Service Bulletin

Bulletin No.: 17-NA-298

Subject: Headliner Sag

Brand:	Model:	Model Year:		Date Breakpoint:		Engine:	Transmission:
		from	to	from	to		
Chevrolet	Camaro Coupe	2016	2019	2016 SOP	Built Prior to October 8, 2018	All	All

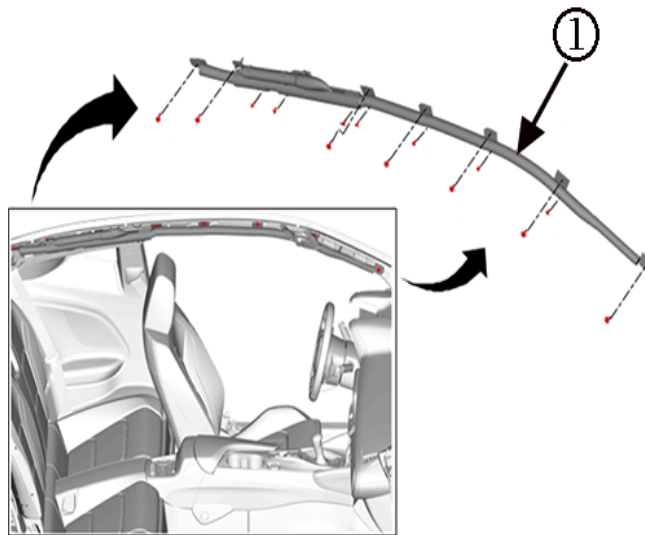
Some customers may comment on seeing the headliner sagging at the front of the passenger side visor. The graphic above shows a view from inside the vehicle, looking upward at the upper corner of the windshield. Sagging may also be evident at front driver side, rear passenger side or rear driver side due to mishandling.

Cause 2

The cause of the condition may be mishandling of the headliner during installation.

For vehicles built prior to the breakpoint noted above, if either condition is evident, it will be necessary to replace the headliner AND both the left (1) and right RRABs. Refer to *Front and Rear Row Seat Roof Rail Airbag Replacement* in SI.
